OFFICIAL STAR CLASS MEASUREMENT CERTIFICATE

YACHT NO. 3,440

Report from International Measurement Committee

Star No. 3440

HEIGHTS									
STATIONS	1	2	3	4	5	6	7	8	9	10
CONTOUR	485	354	240	156	112	105	138	199	284	391
CHINE			284			228		305		462
SIDE *	392		548			538		440		380

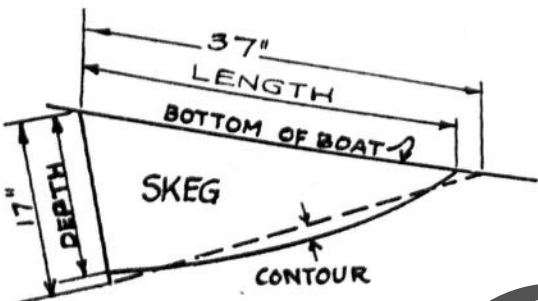
HEIGHT SIDE (#1) 342 MAX 371.475
 (#3) 548 MAX 534

Star N^o 3440 owner Violette has been remeasured for the points which did not comply with the specification and it seems evident that they had been taken in a wrong place the first time ; they really are as follows :

Height Side (1) 370

" " (3) 529
